DEC-12-HVRTP-A-D

**VR14 and VR20
troubleshooting
procedures**

Figure 1 7007165 Power Regulator Assembly

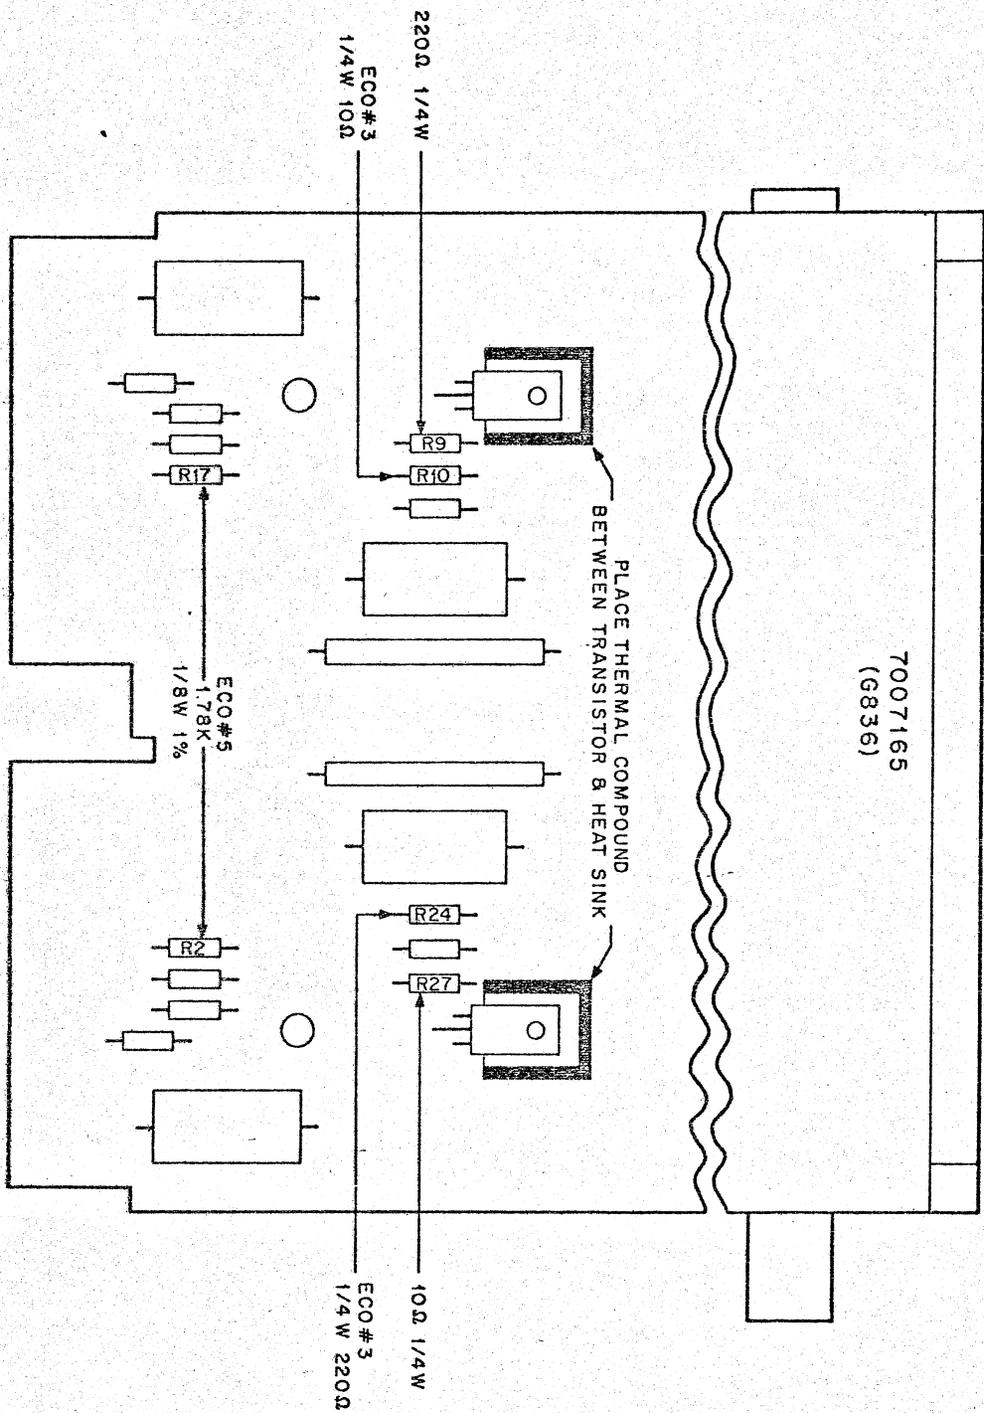
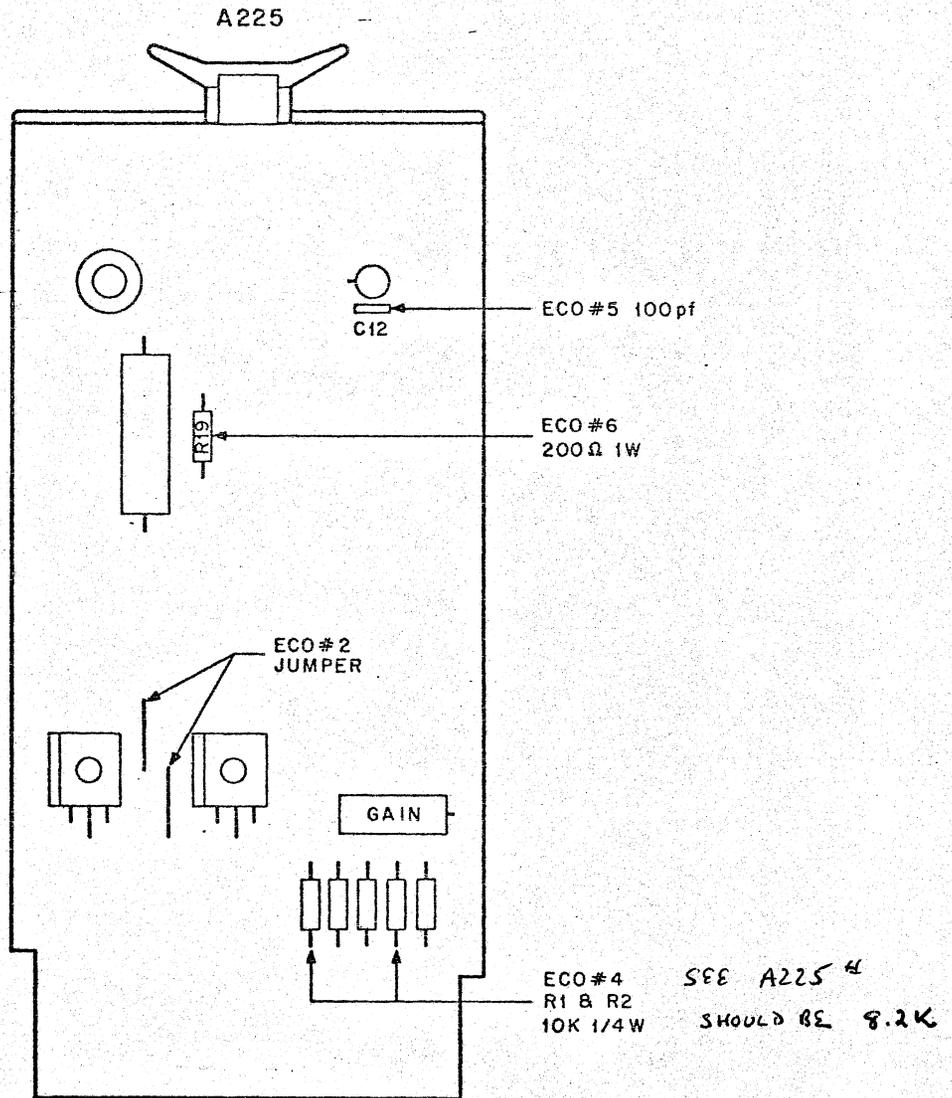
4. Check the G836 regulator card on the 7007165 to ensure all ECOs have been incorporated (See Figure 1).
 - a. R9 and R24 should be 220Ω , not 1K.
 - b. R10 and R27 should be 10Ω , not 150Ω .
 - c. R2 and R17 should be 1.78K, 1% resistor, not 1.62K, 1%. This lowers the +24V to +22V.

Note that ECO #G836-5 (see Figure 1) changes the value of resistors $\pm 23/5V$ to $\pm 21.5V$, thereby reducing the deflection heating.

Figure 3 Deflection Heat Sink

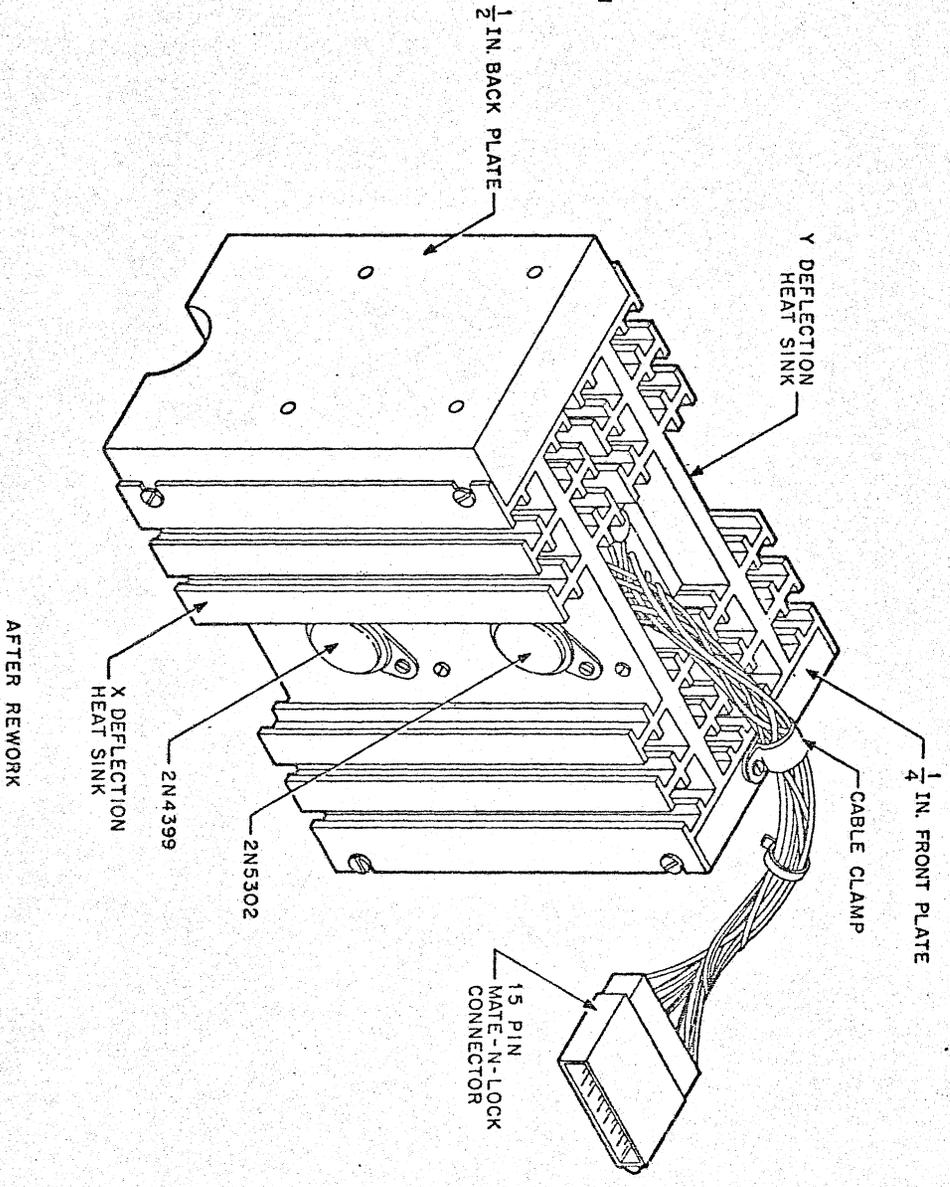
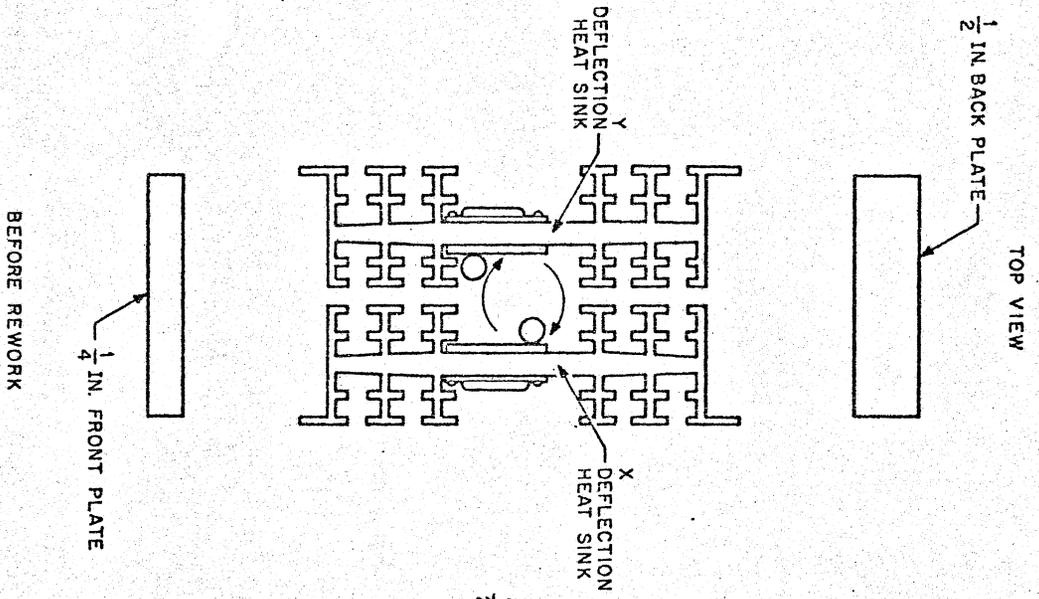
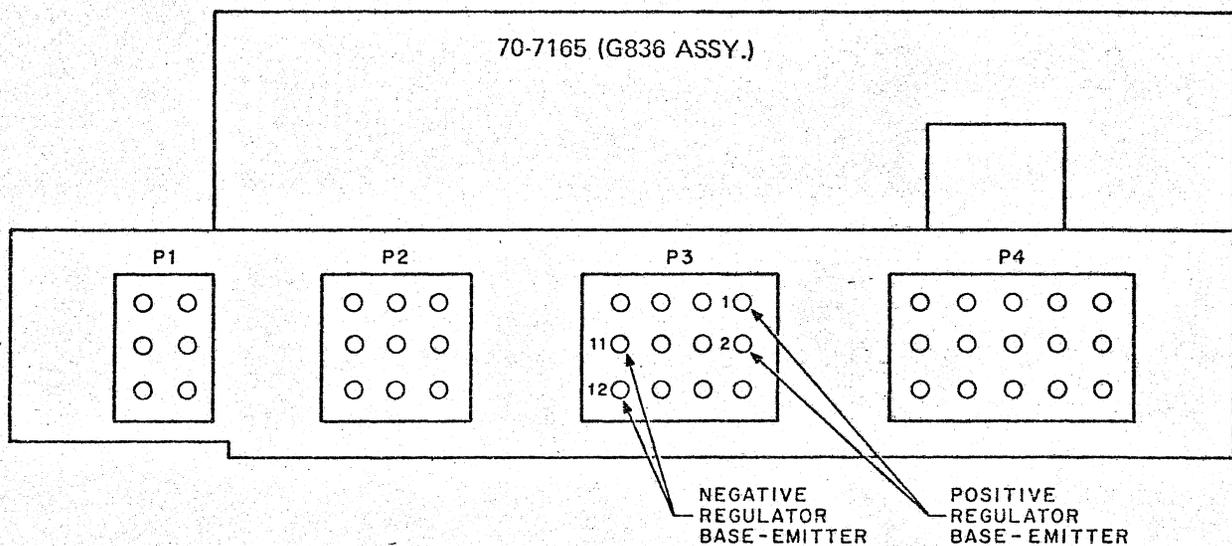
6. In order to increase heat dissipation for the power transistors, ECO #VR14-15 must be installed. This ECO consists of physically interchanging the inside section (X) of the deflection heat sink assembly with the outside section (Y). This is done because the outside section receives better air flow. Since X generates more heat than Y, X requires more cooling air.

The interchange is accomplished by unscrewing the end plates of the heat sink assembly, exchanging the heat sinks so that X heat sink is on the outside, and then replacing the end plates.

Before reassembly, remove the thermal cutout on the X heat sink and replace it with a 6-32 screw to hold the terminals on the inside. Place a jumper plug across the thermal cutout leads because the cutout is no longer used and the line circuit must be completed.

1. Remove deflection heat sink assembly from the VR14.
2. Remove 6-32 X 3/8 screw that secures cable clamp to 1/4-inch front plate.
3. Remove eight 6-32 X 1/4 screws that secure X and Y heat sinks to front and back plates.

4. Remove thermal cutout from X deflection heat sink and place a 6-32 X 1/2 pan head screw in the hole.
5. Place 1/2-inch back plate on a flat surface with the two mounting screws (used for securing heat sink) facing up and half-circle cutout facing the bottom.

6. Secure the X deflection heat sink (identified by grey wire on transistor collectors) to the 1/2-inch back plate, using two 6-32 X 1/4 screws. Make certain the 2N4399 transistor is on the bottom.

7. Place 1/4-inch mounting block on other side of the X deflection heat sink with the cable clamp screw hole facing the top. Secure with two 6-32 X 1/4 screws.

8. Secure the Y deflection heat sink (identified by violet wire on transistor collectors) to the opposite side of the assembly, ensuring that the 2N4399 is on the bottom.

9. Secure the cables from X and Y deflection heat sinks to the top of the 1/4-inch front plate with cable clamp and 6-32 X 3/8 screws.
10. To complete the AC line circuit, place a jumper plug (7007006-3) in the 2-pin connector that was connected to the plug for the thermal cutout.
